**From:** WILLIFORD Dennis (RS/NB)  
**Sent:** Friday, May 20, 2011 5:32 PM  
**To:** Tesfaye, Getachew  
**Cc:** BENNETT Kathy (RS/NB); DELANO Karen (RS/NB); ROMINE Judy (RS/NB); RYAN Tom (RS/NB)  
**Subject:** Response to U.S. EPR Design Certification Application RAI No. 442, FSAR Ch. 7, Supplement 9

**Subject:** Response to U.S. EPR Design Certification Application RAI No. 442, FSAR Ch. 7, Supplement 10  
**Sent Date:** 5/25/2011 7:42:21 AM  
**Received Date:** 5/25/2011 7:43:22 AM  
**From:** WILLIFORD Dennis (AREVA)

**QUESTIONS for Instrumentation, Controls and Electrical Engineering 1  
(AP1000/EPR Projects) (ICE1)**

**Question 07.01-27:**

Figure 7.2-3—Manual RT

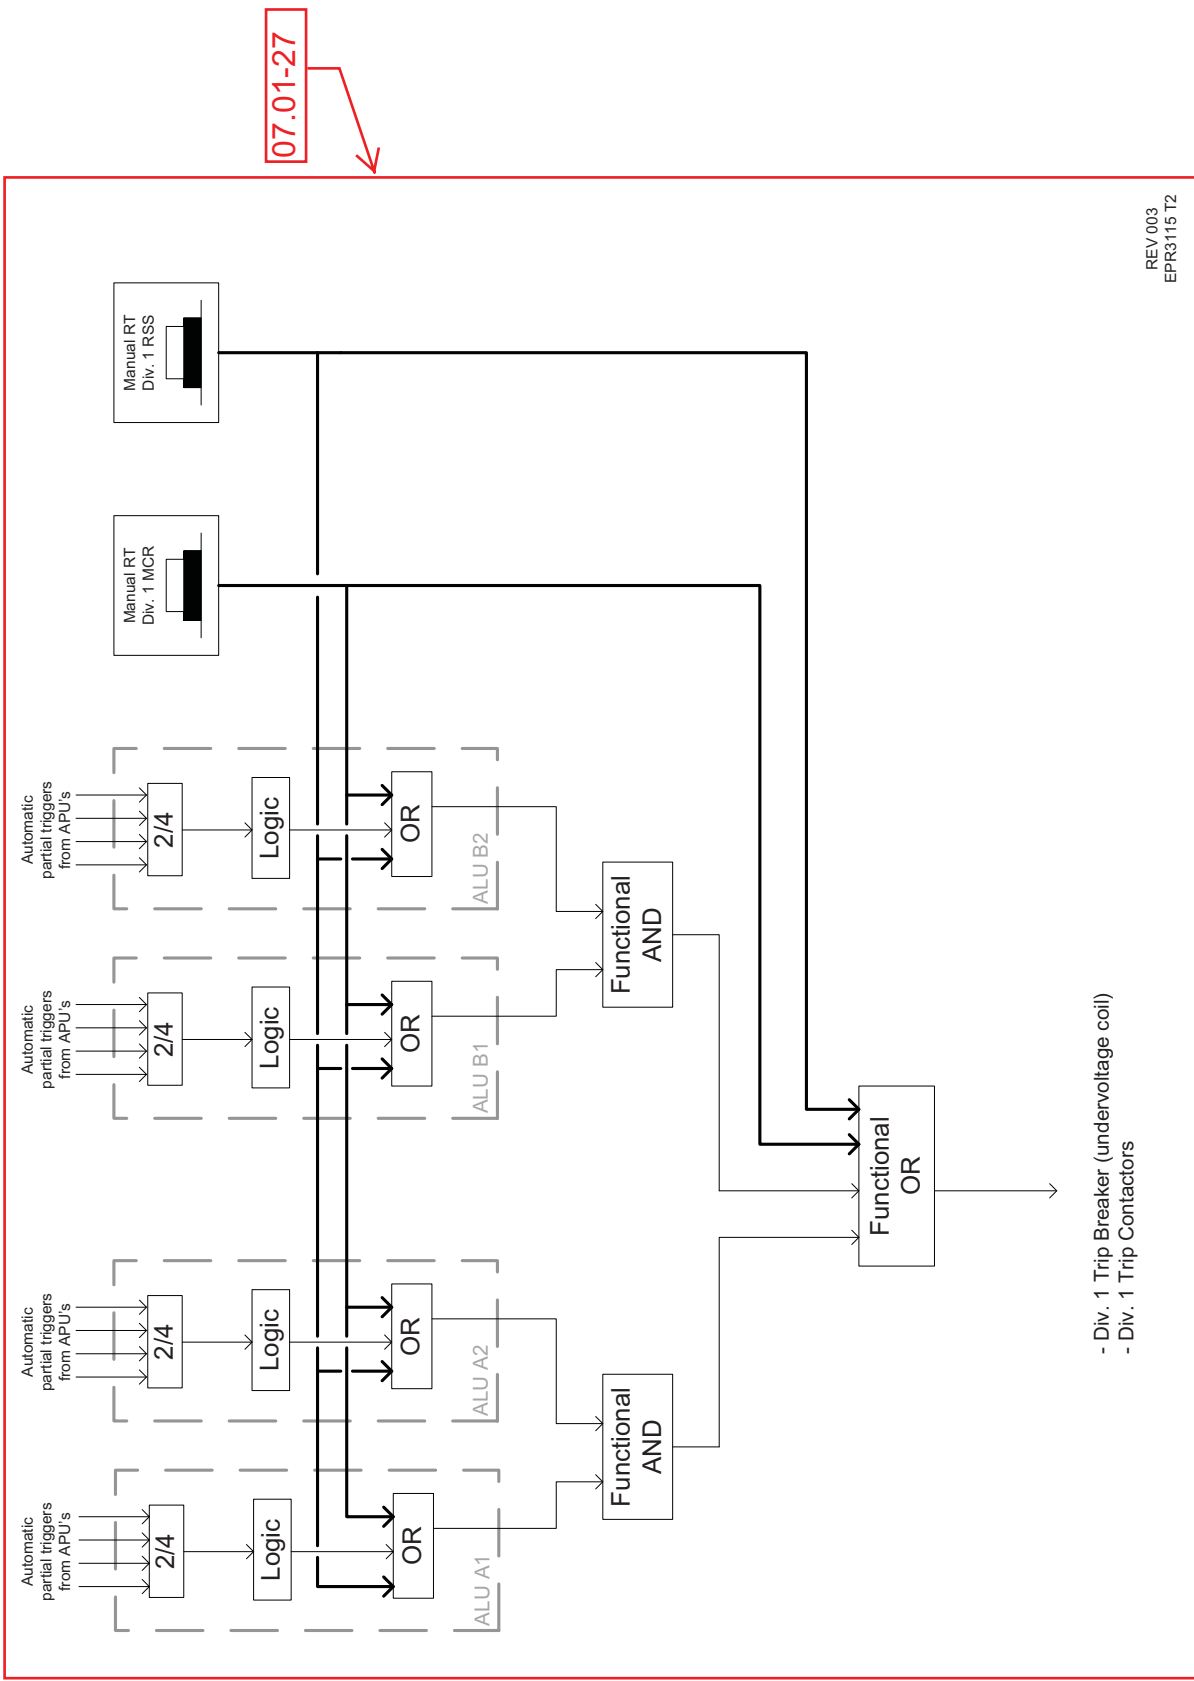
Technical Report ANP-10309, "U.S. EPR Digital Protection System" will be revised to include the information requested in this RAI. U.S. EPR FSAR Tier 2, Sections 7.2 and 7.3 will be revised to remove the protection system (PS) FMEA information. The PS FMEA information will be provided in the Technical Report ANP-10309, "U.S. EPR Digital Protection System."

Any one of ~~three~~two diverse sets of RT devices can successfully remove power to the CRDM coils. The sets are the ~~RT~~reactor trip breakers (RTB), and the ~~RT~~reactor trip contactors (RTC), ~~and the transistors of the CRDM operating coils~~. When an RT order is generated, the PS acts on ~~all three~~both sets of RT devices as described:
